PRODUCT INFORMATION SHEET - CYLINDER HEAD GASKETS

UE31004P - UT12890PD - 07V103147

TSD4446 - SZ/E11 - Page 1 of 3

CYLINDER HEAD GASKETS

Fig 3 New Gasket Now Used on
ALL Engines (UE 45215)
A One hole has been deleted
B Push rod hole decreased
in size

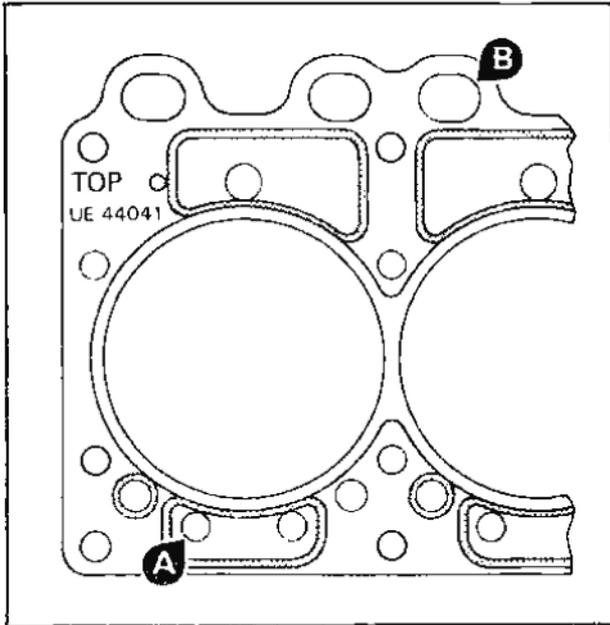
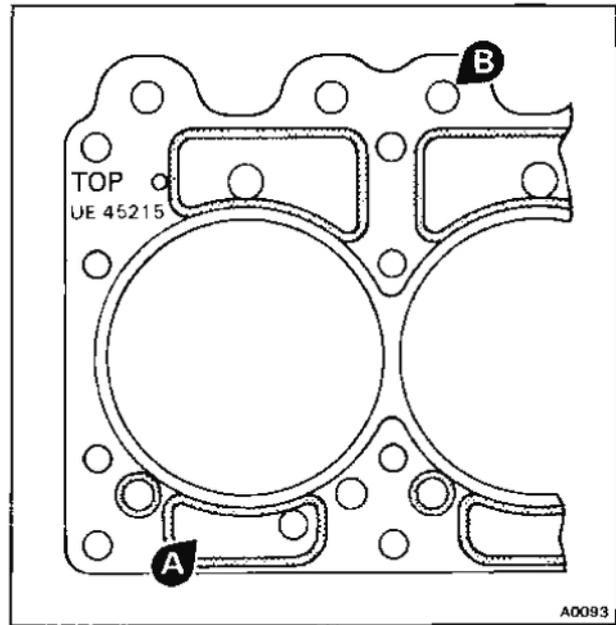
An improved cylinder head gasket has been introduced on the above cars. Minor changes have also been made to the cylinder head.

The new cylinder head gasket is similar to that used previously on the Bentley Mulsanne Turbo engine. However, changes have been made to the push rod hole size and one of the coolant hole passages has been deleted (see figs.1 and 3).

The latest gasket (UE 45215) can be used for ALL Bentley Mulsanne Turbo engines, but MUST NOT be used on normally aspirated engines prior to vehicle identification numbers listed above. UE 31004 must be used on all these earlier engines.

The new gasket (UE 45215) should be assembled dry.
